ADDENDUM

No. 2

**Humanities Building Central Plant
Cooling Tower Replacement, Rockville Campus**

Project:	MC RV HU (BLDG No. 208) Central Plant Cooling Tower Replacement	Date:	10/28/2019
		Reference:	
Title:	Addendum #2 Drawing Narrative	BKM Project No:	19104.01

E1.04

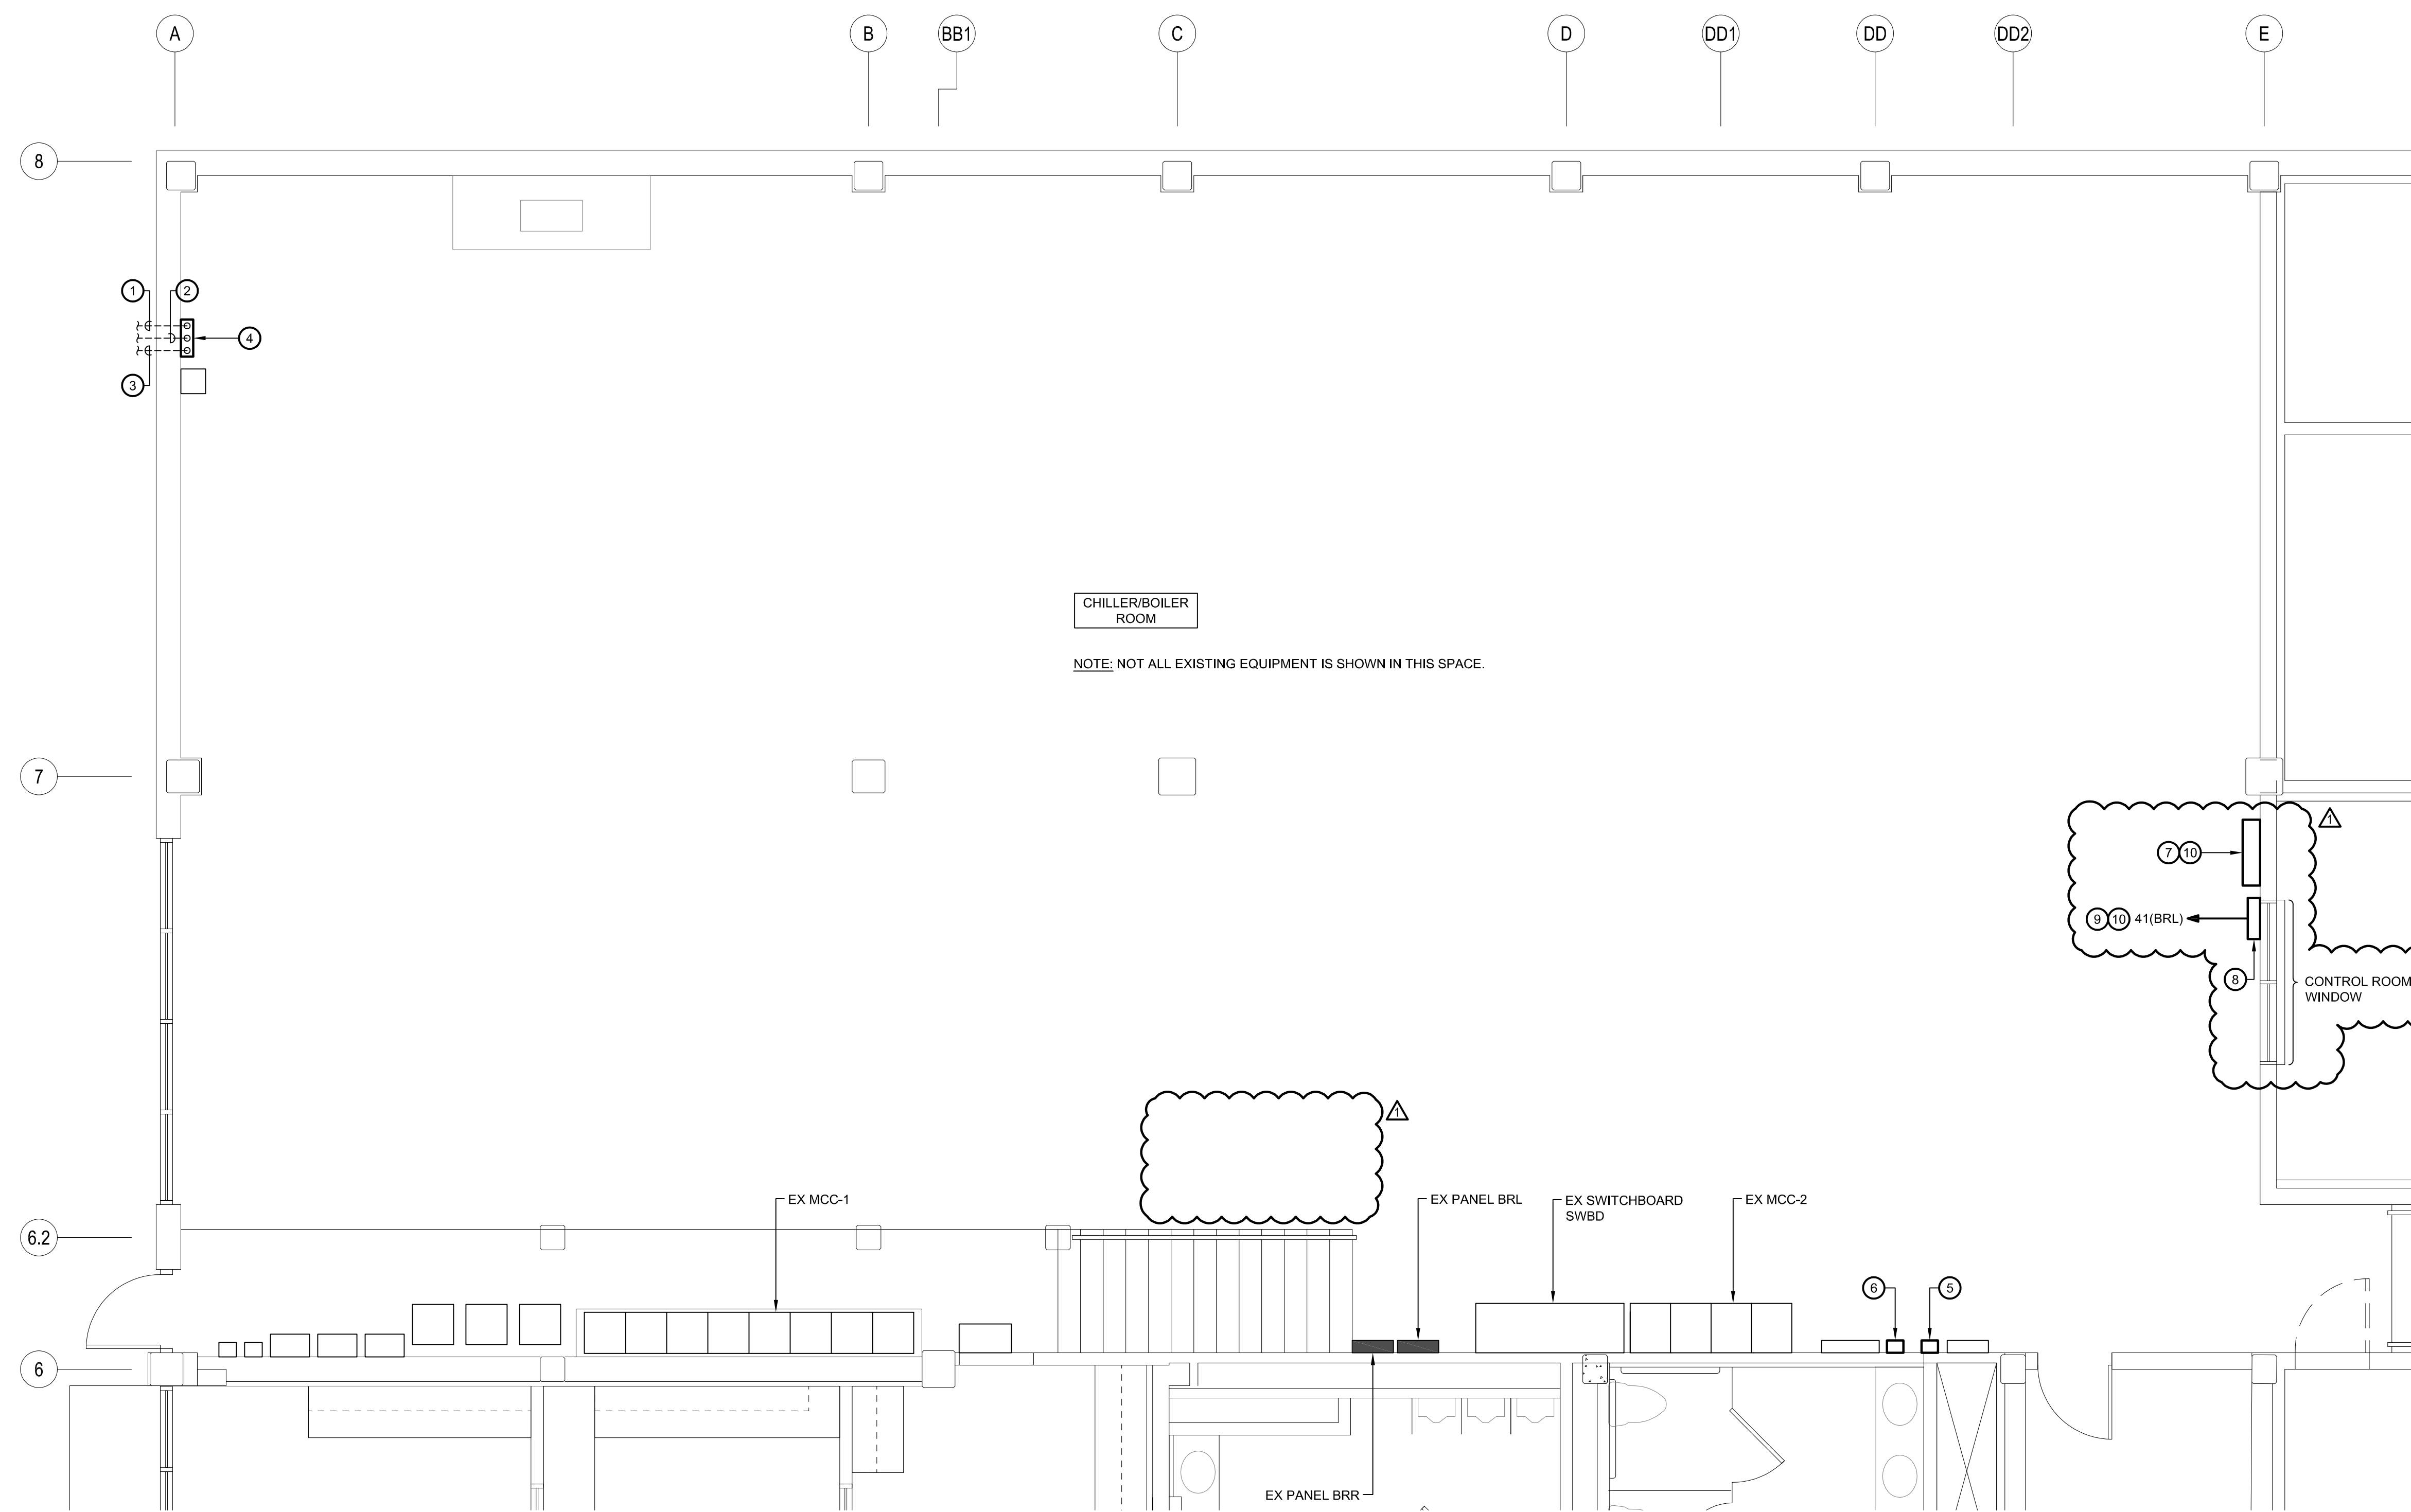
E1.04 "Humanities Building Part Floor Plan – Power – New Work"

- The location of panel board PP1 and the BAS panel has been identified.
